**Engineering Analysis (EA-FC-04-010) Recommendations for Implementing of  
Compensatory Actions in Response to NRC Bulletin 2003-01**

EA-FC- 04-010	Rev. No. 0	EC#: <del>30663</del>	Page No. 1		
EA TITLE (include computer program designation):			Total Pages 91		
Recommendations for Implementing of Compensatory Actions in Response to NRC Bulletin 2003-01					
QA CATEGORY:		REPORT TYPE:			
<input checked="" type="checkbox"/> CQE <input type="checkbox"/> Fire Protection <input type="checkbox"/> Non CQE <input type="checkbox"/> Limited CQE		<input type="checkbox"/> Revision <input checked="" type="checkbox"/> Analytical Report <input type="checkbox"/> Special			
ENGINEERING ANALYSIS TYPE:					
<input type="checkbox"/> Electrical Equipment Qualification (EEQ) <input type="checkbox"/> Seismic Equipment Qualification (SEQ) <input type="checkbox"/> Core Reload Analysis (CRA) <input type="checkbox"/> Fire Hazards Analysis (FHA) <input type="checkbox"/> Cable Separation Analysis (CSA) <input type="checkbox"/> Associated Circuits Analysis (ACA)		<input type="checkbox"/> Safe Shutdown Analysis (SSA) <input type="checkbox"/> Computer Code Error Analysis (CCE) <input type="checkbox"/> Nuclear M

Figure 5.1-1 above shows the Boiloff rate and total SI pump flow to match decay heat vs. time to T=100 minutes [3.16; Figure 2]

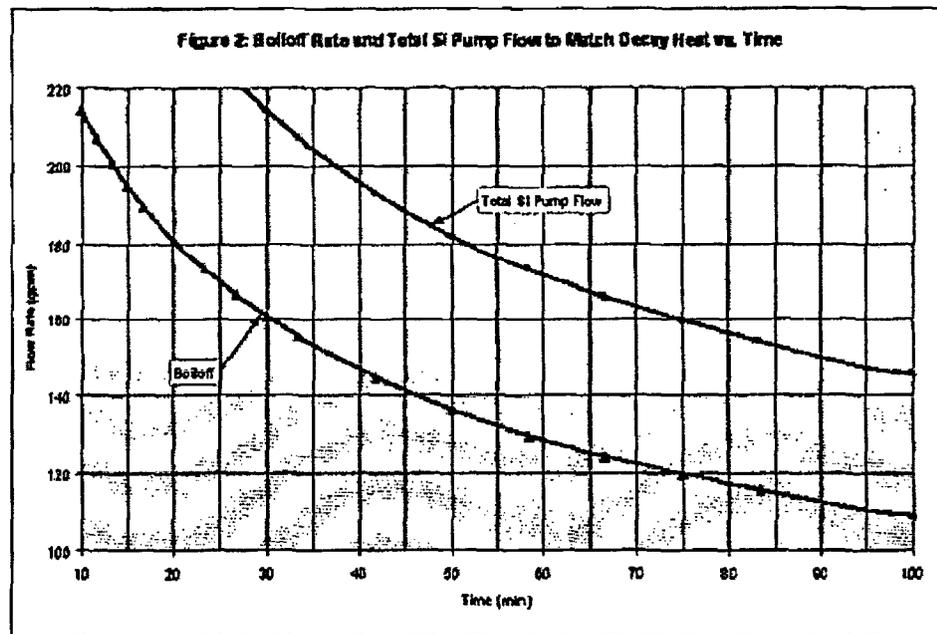
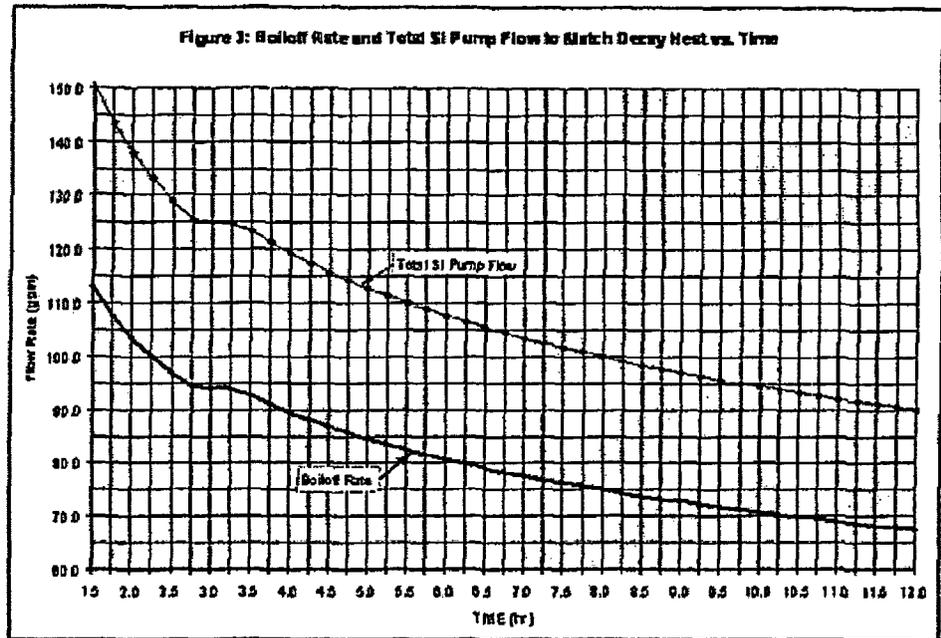
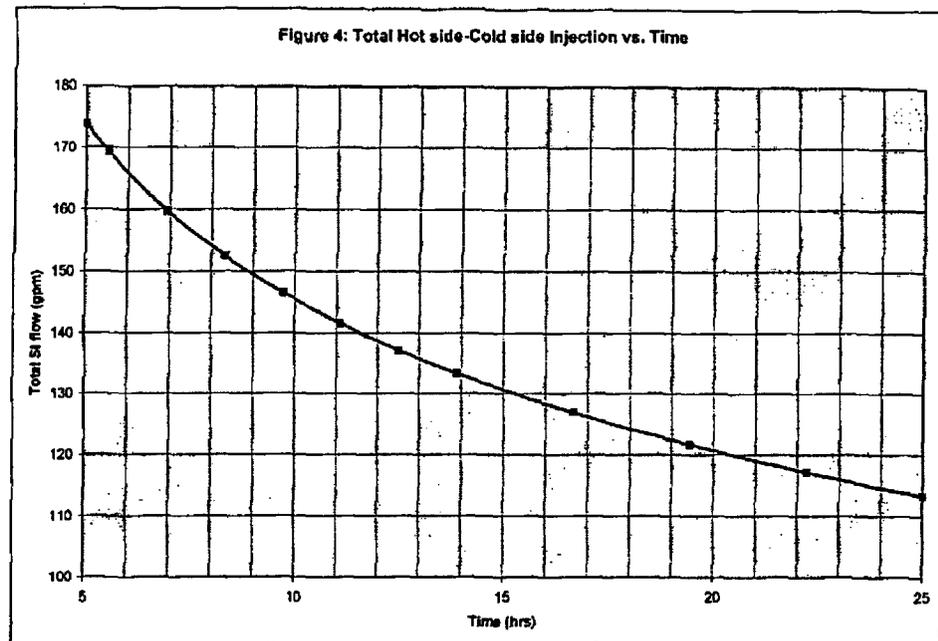
9	18	Fig 2 is of poor quality. Difficult to read.	Replaced Figures with more readable quality figures
10	25	Section is titled, "Effect of Rising Water Level on Components, Penetrations and Cables", yet there is no stated consequences or impact statement.	Added impact statement at the end of the section.
11	31	Radiological considerations. No impact statement on source term reduction.	After discussion with the reviewer, the paragraph was removed.  The impact on source term reduction was discussed earlier in the evaluation on p. 15. Having this paragraph on p. 31 adds no value and is confusing.
12	31, forth bullet	Editorial. Add "for".	Corrected
13	31, fifth bullet	Do you mean, "below" 1000.9. It reads now as "above".	"above" is correct in this instance. The statement is intended to convey that as containment water level is raised above the EEQ flood level of 1000.9 ft, that submergence of non-submergence qualified equipment may cause erroneous readings or failures.

14	32, step 3, second paragraph	Editorial. Add "a" after "to".	Corrected
15	18	Suggest placing Figure 5.1-1 under graph. Not easy to distinguish this graph as Fig. 5.1-1. Same with other graphs.	Incorporated
16	33, forth paragraph	Provide reference to source document for ...3 out of 4 SIT tanks. Also, it would be SI tanks or SITs.	Inserted Reference, Corrected usage for SIT
